**From:** William Ward  
**To:** Frank Festa  
**Date:** 8/2/01 5:50PM  
**Subject:** Final questions

Review of your application is complete. I have 3 final questions as a result.

Source Label

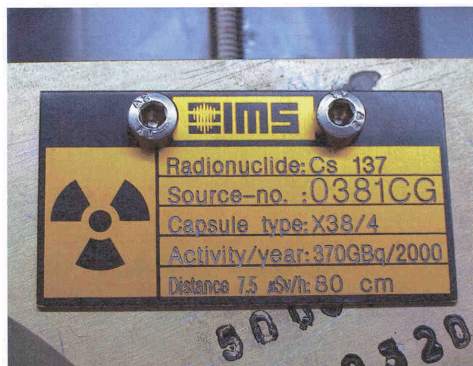
1. No "in-beam" radiation levels were given. Do you have any calculations or estimate to show what this would be?
2. Concerning the activity and date provided on your label, please state if you are entering an actual activity or a nominal activity and date? Is it possible to put month/year instead of just year? I've attached a copy of the label you sent with your application to make for easy reference.
3. Concerning your QA program (8/1 version sent to me is attached). It says it is "Manufacturer's Program Outline". I know that you, the distributor, are owned by IMS-Germany, the manufacturer. Please state to whom this program applies, or if it applies to both of you. Is all manufacturing related QA performed by the manufacturer at their facility?
